## MEMORANDUM

RE: **Dunes Club, Healy, and Barry Properties  
CRMC Wall Maintenance Comments  
Narragansett, RI  
Pare Project No. 25115.00**

R. Lucia's 09-18-2025  
Email pgs 5 & 6

**SECTION C - EXISTING CONCRETE SEAWALL**  
SCALE: 1/2" = 1'-0"

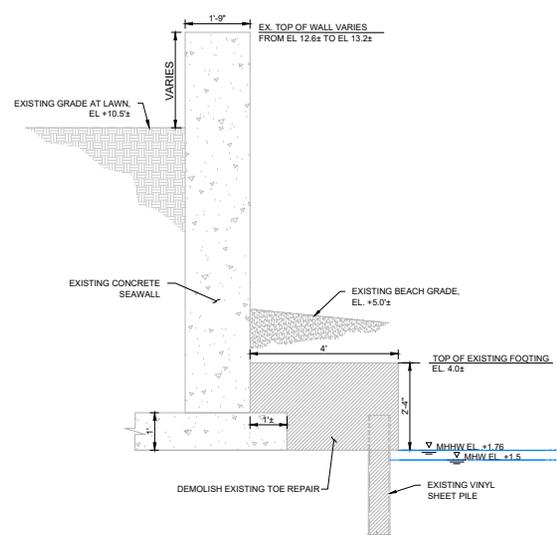
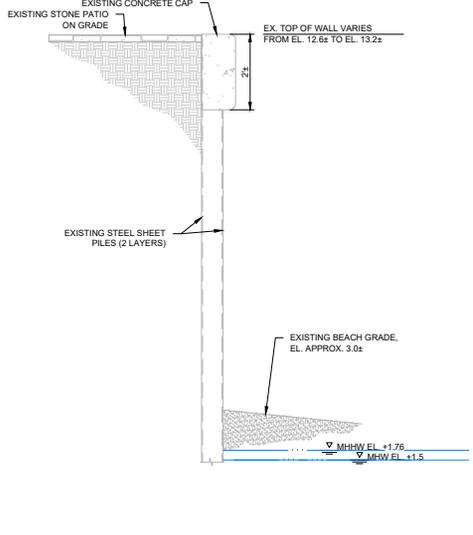
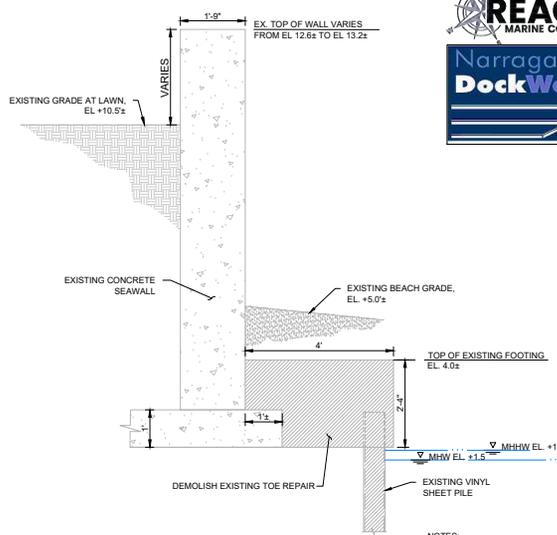
- *Comment/Question: at Berg property there was a toe repair performed with a larger footing and sheetpiles at "Section C", this is not shown on the plans, please clarify. For clarity lets call it the "Ernie George Plan" henceforth.*

- *Comment/Question: At Healey property there was an Assent to build the "Ernie George Plan". The submitted cross section do not show this, the existing footing would be larger than shown on submitted plans. Is this footing going to be reconfigured like Bergs?*

- *Comment/Question: Dunes Club shows a 3'-6" footing. (Does this have the Ernie George Plan" footing with sheetpile scour protection).*

- *Comment/Question: Before I put these projects out to notice, all the plans need to show the accurate footing elevations (existing and proposed) as well as the new clearance height of wall above the new footing (e.g. distance from top of footing to top of wall). Also, the seaward extent of the existing and proposed footing of Healy project.*

**Response:** Section C has been updated and is attached for submission. It should be noted that the larger footing was not found during the test pit excavation conducted by NDW/Reagan, and it is uncertain whether it was installed as permitted for the entire length.

**Response:** During the test pit excavation, the repair found on this property was a flow fill under the wall, not the same repair as the Barry (Berg) property; therefore, the plans indicated that the footing extents will be confirmed during the installation and will need to be removed/adjusted accordingly. As-builts of the repair were not available to Pare.

**Response:** No, this does not have the "Ernie George Plan footing" this is the footing from the original wall repair. The bottom of the footing was previously exposed and was confirmed from the test pit exaction performed by NDW/Reagan.

**Response:** Cross sections have been updated to provide additional information requested.

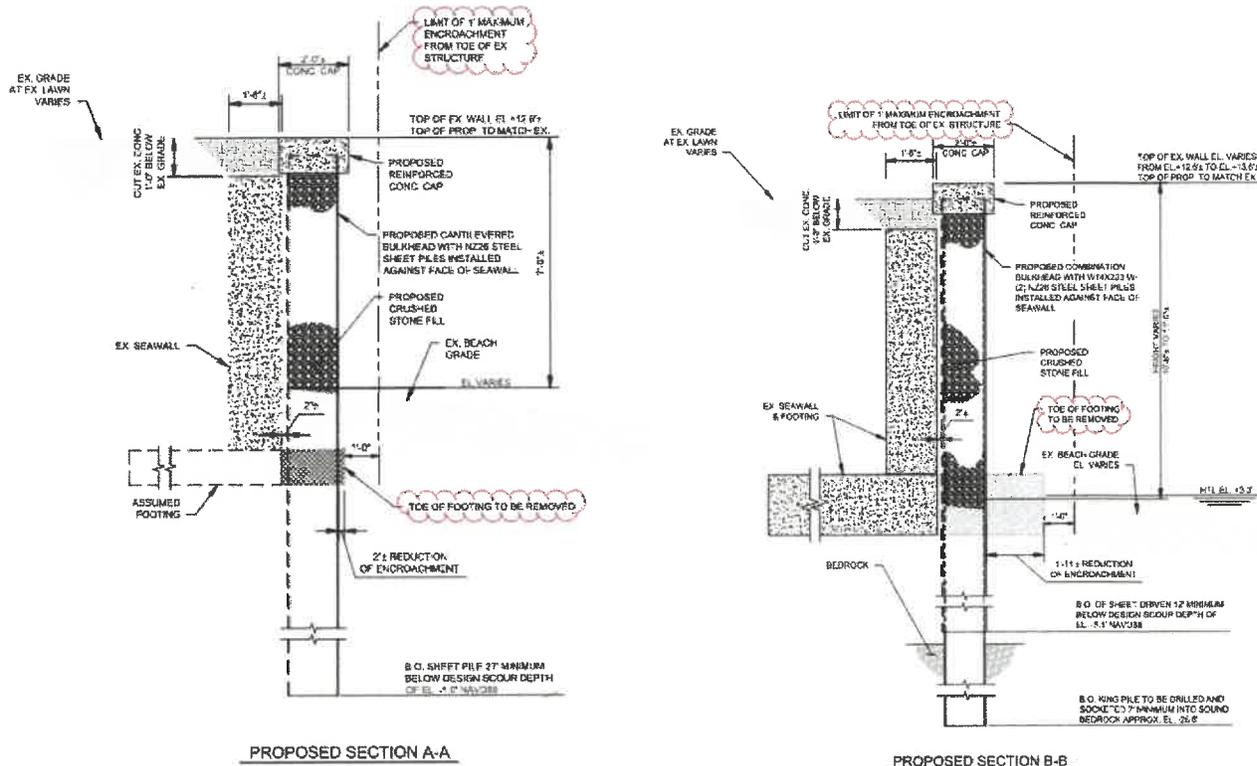
*The proposed new shoreline protection does not meet the standards of the 650-RICR-20-00-1.3.1.(G).6.(a). and would be considered new construction which would be prohibited on this shoreline (Type I, Conservation area) "The maintenance or repair of shoreline protection shall not extend beyond one (1) foot seaward of the existing toe of the structure. In most cases, expansion of the shoreline protection structure beyond one (1) foot seaward of the existing toe and one (1) foot vertical above the existing or shoreline protection elevation will be considered new construction."*

*As submitted the wall will extend (Cross Section D-D) 20.32" seaward (3" (start of sheetpile) + 17.32" (height of NZ26)). The design will need to be revised in order to meet the 12" requirement. Cross Section E-E has the same issue, the wall will sheetpile, this will extend 20.32" (3" + 17.32" height of NZ26).*

*Additionally, regarding the depth of sheetpile (NZ26), please give the design depth of scour on plans.*

The proposed maintenance work will remove the existing toe of the concrete footings that extend waterward approximately 8” to 48” from the face of the seawall, as authorized under Ascent 1992-01-050 and then drive new sheetpiles as close to the existing seawall face as possible in the following sequence. We will excavate sections in front of the existing walls to expose the footing while simultaneously bracing the wall. With the footing exposed and the work area safe, removal of the footing toe with concrete saws and or hydraulic demolition hammers will be executed. The demolition materials will be removed from the site and legally disposed of at an authorized facility. Once a section of the existing seawall toe is removed, a casing will be installed down to bedrock.

Once the casing is installed, a King pile(s) will be drilled and set with grout a minimum of 7' into bedrock. Once the king piles are set, steel sheeting will be driven to bedrock in between the piles. The process would continue in approximately 25' to 50' sections until the work is complete. This selected repair alternative reduces the encroachment of the seawall seaward by removing the existing seawall toe and keeping the repair within one (1) foot of the existing toe location. Below is a cross section of the proposed repair that graphically details the above description.

The proposed repair option has been chosen after careful consideration of the other alternatives specifically so that it will meet the standards for Maintenance and Repair of shoreline protection. The construction sequence discussed above and shown on the proposed cross-sections demonstrate this. It is our opinion that the design as shown does not need to be revised as it meets the 12" requirement.

The design scour depth is based on USACE recommended methodology. For this project the scour depth is -1' NAVD88 and the sheets shall extend 27' below that elevation in one location and -5.1 NAVD88 in the other location with the sheets a minimum of 12' below. This is also detailed on the proposed repair plans in the application.

**TEMPORARY ACCESS PLAN**

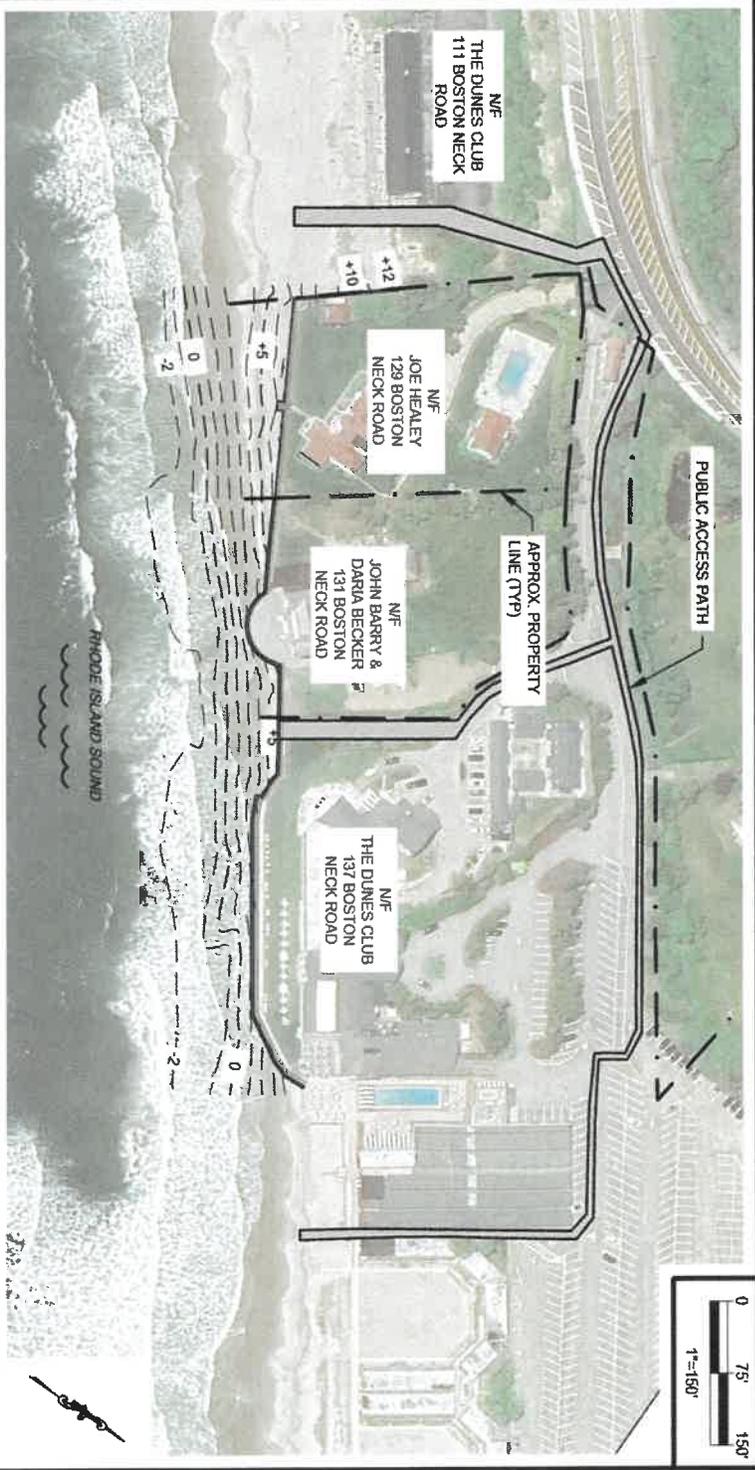
*The project, as proposed, does not demonstrate the negative impacts to public access have been minimized to the maximum extent possible.*

*Lateral shoreline access may be negatively impacted by the proposed work. Applicant shall need to submit a plan which mitigates the negative impacts to lateral public access as part of this application.*

*The public access plan will need to provide long-term maintenance of the proposed access pathway/route.*

The proposed project minimizes negative impacts to public access to the maximum extent possible. Impacts to public access are temporary during construction. A temporary access path will be provided as depicted within the attached drawing such that the public can still have access along the beach. It is important to note that during high water events, access from the Town beach to the river is limited in front of 131 Boston Neck Road unless you wade through water. Access would be maintained and continue during non-high water events as currently exists. Additionally, there would be a significant adverse impact to the public access should repairs not be completed and failure was allowed to occur. Debris, upland soils, underground structures, and other upland amenities on this property would end up impacting the beach and create a significant hazard to the beach as well as the water body.

Please see the public access plan included in the drawing set.

No permanent impacts to public access are anticipated as part of this project. Access will remain as currently existing once the project is complete, limited during high water events and unrestricted during low water events.
